Response to reviewers

This paper shows an example of the application of the statistical SPARROW model to the Ishikari River basin. As a result, the modeled result is likely reasonable to the observed annual sediment load as shown by Fig. 6. However, the Ishikari River basin is located in the subarctic region with high snow depth in winter. It should be noted that: i) The Ishikari River basin has a long period of low flow and sediment load in December to mid-March with high snowfall. For this period, sediment load is very low except for the temporary snowmelt at positive degree air temperature. ii) High flow and sediment load are observed in the snowmelt season of mid-March to May and in heavy rainfalls in May - late November. Thus, (1) the sediment load estimated by the SPARROW model should focus only on the snowmelt and/or rainfall river runoffs. Otherwise, the authors should explain such a natural condition as the background of the river basin to the readers, and apply the SPARROW model to river runoffs for the limited period. (2) If the “developing land” produces the high sediment yield even in winter, they have to state why and how the high sediment yield is produced. The auth

Fig. S1 Rain gauge station distributions used in this study

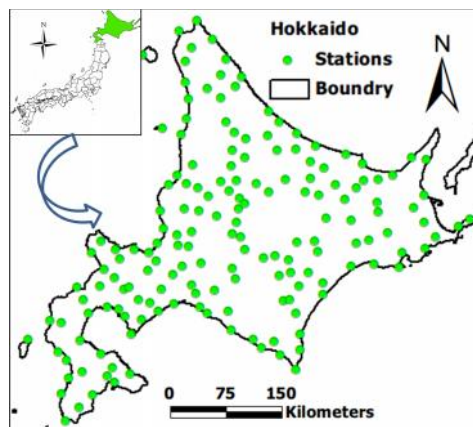
Sub-question 5: *Actual evapotranspiration from the river basin is never explained in the text. The effective rainfall in the rainfall season is one of important parameters to produce river runoffs and sediment load. The authors should utilize the MET data at many weather stations in the river basin for the modelling.*

Response: Climatic and landscape characteristics considered candidates for SS-transport predictors include climate, topography and soil. In this study slope, soil permeability, and precipitation are used to evaluate the influences of “land-to-water” delivery terms. So we did not use the effective rainfall, but use the total precipitation including snow and rainfall. Section 2.3.4 shows how and when the MET data were used to calculate the precipitation distribution in the Ishikari River basin (see following explanation).

Mean annual precipitation data, representing the 20-year (1990-2010) average, were obtained from daily precipitation data at 161 weather stations (see Fig. S1) in Hokkaido from 1990 to 2010. We first interpolated the mean annual precipitation over Hokkaido using a conventional kriging technique on the basis of 161 stations, and then clipped the mean annual precipitation distribution for the Ishikari River basin.

We have added some explanations about why and how the MET data were used to obtain the precipitation distribution.

Fig. S2 Schematic illustration of a reach network for five incremental watersheds (Total Load at X = L1+L2+L3+L4+L5, Incremental Load at X = L5 only).

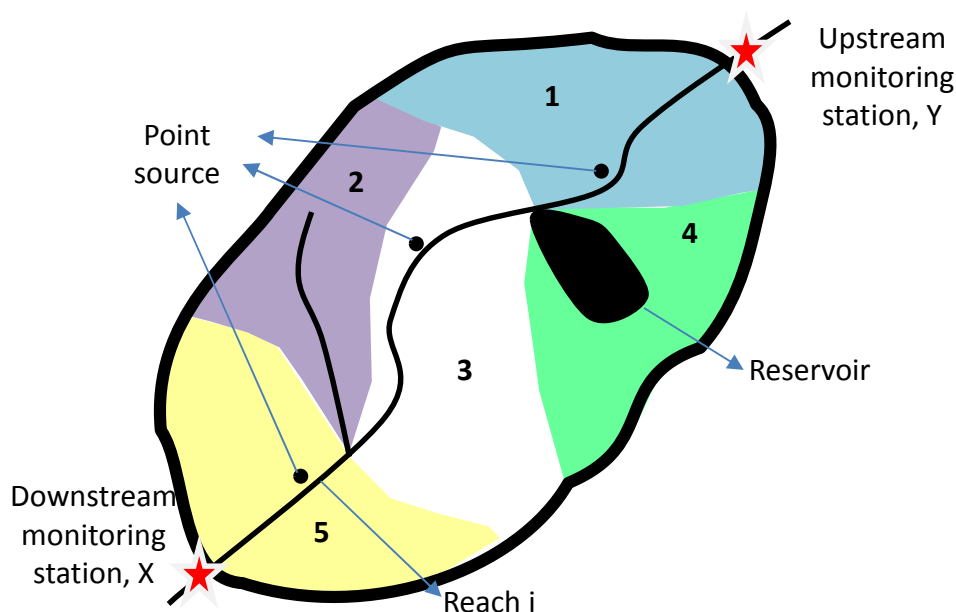
Question 4: Fig 8 and 9: It is not clear what is incremental? Should be explained.

Response: The total yields (load per area) represent the amount of sediment including

upstream load and local catchment load contributed to each stream reach, and the incremental yields represent the amount of sediment generated locally independent of upstream supply, and contributed to each stream reach, normalized by the local catchment area (see following explanation).

We are very sorry for our vague expression. So, this has been clarified in the text.
